UNITED STATES PATENT AND TRADEMARK OFFICE

APPLICATION NO.	FILING DATE	FIRST NAMED INVENTOR	ATTORNEY DOCKET NO.	CONFIRMATION NO.
10/812,960	03/31/2004	Chih-Kang Wu	SUND 512	4884
23995	7590	12/14/2005	EXAMINER	
RABIN & Berdo, PC 1101 14TH STREET, NW SUITE 500 WASHINGTON, DC 20005			HAN, JASON	
			ART UNIT	PAPER NUMBER
			2875

Office Action Summary	Application No. 10/812,960	Applicant(s) WU, CHIH-KANG	
	Examiner Jason M. Han	Art Unit 2875

DETAILED ACTION

FIG. 1

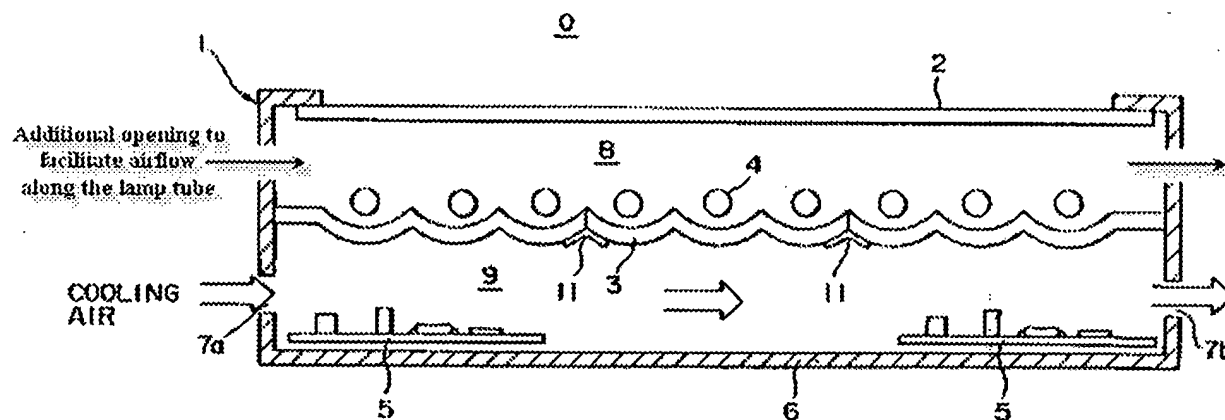
However, it would have been obvious to one having ordinary skill in the art at the time the invention was made to incorporate two opposite openings located at two ends of each side region separately, since it has been held that mere duplication of the essential working parts of a device involves only routine skill in the art. *St. Regis Paper Co. v. Bemis Co.*, 193 USPQ 8. In this case, providing additional openings would only facilitate heat transfer within the system, especially with airflow along the lamp as shown in the drawing below.

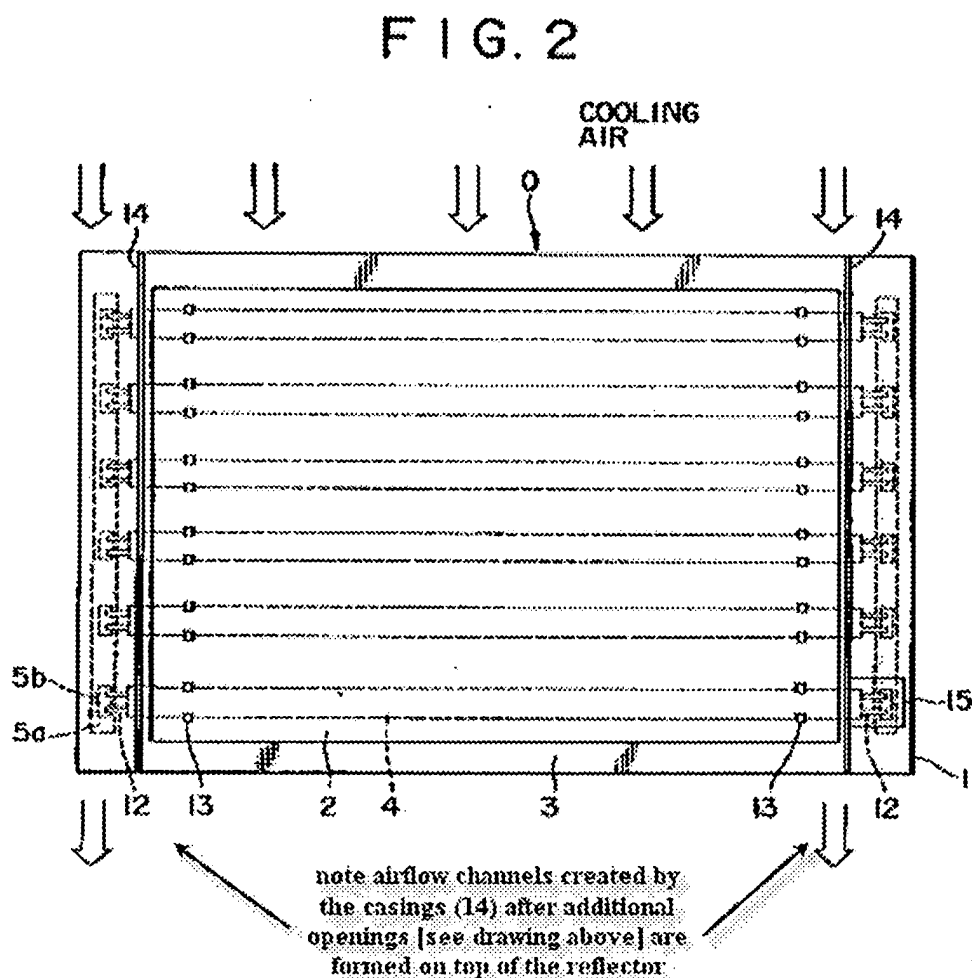
7. With regards to Claim 2, Yamamoto discloses the claimed invention as cited above. In addition, Yamamoto teaches a casing [Figure 2: (14)] for covering the buffer block [Column 4, Lines 23-34], and allowing an airflow channel to be formed by the combination of an inner chamber of the casing and the openings when the casing is installed in the reflective base [see drawing below].

FIG. 1

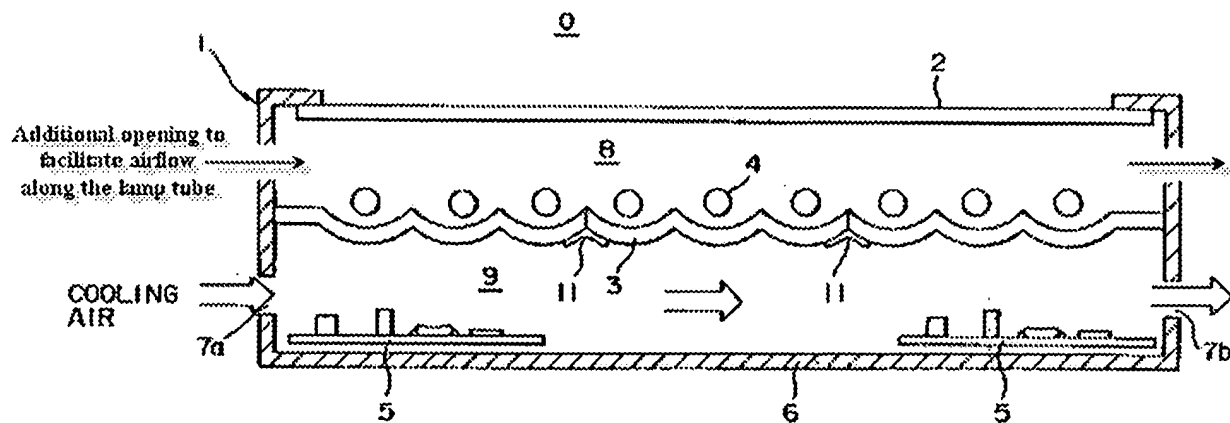
However, it would have been obvious to one having ordinary skill in the art at the time the invention was made to incorporate two opposite openings located at two ends of each side region separately, since it has been held that mere duplication of the essential working parts of a device involves only routine skill in the art. *St. Regis Paper Co. v. Bemis Co.*, 193 USPQ 8. In this case, providing additional openings would only facilitate heat transfer within the system, especially with airflow along the lamp as shown in the drawing below.

FIG. 2

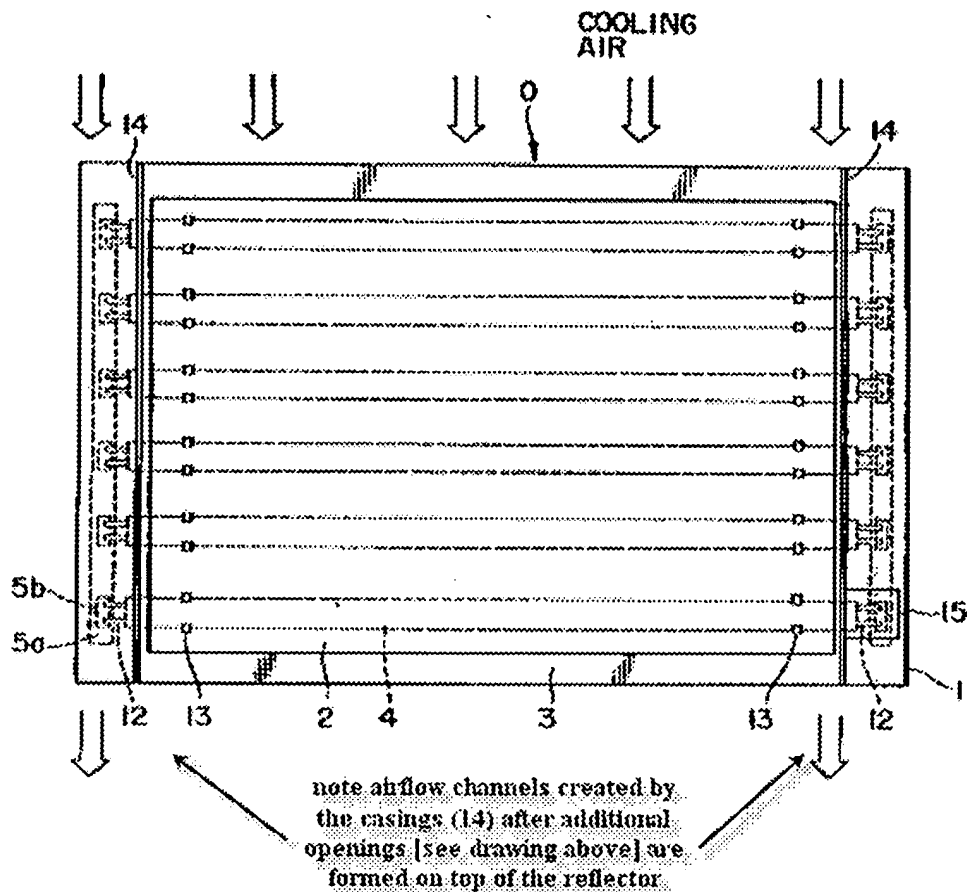
14. With regards to Claim 9, Yamamoto in view of Hayashi discloses the claimed invention as cited above. In addition, Yamamoto teaches a casing [Figure 2: (14)] for covering the buffer block [Column 4, Lines 23-34], and allowing an airflow channel to be formed by the combination of an inner chamber of the casing and the openings when the casing is installed in the reflective base [see drawing below].
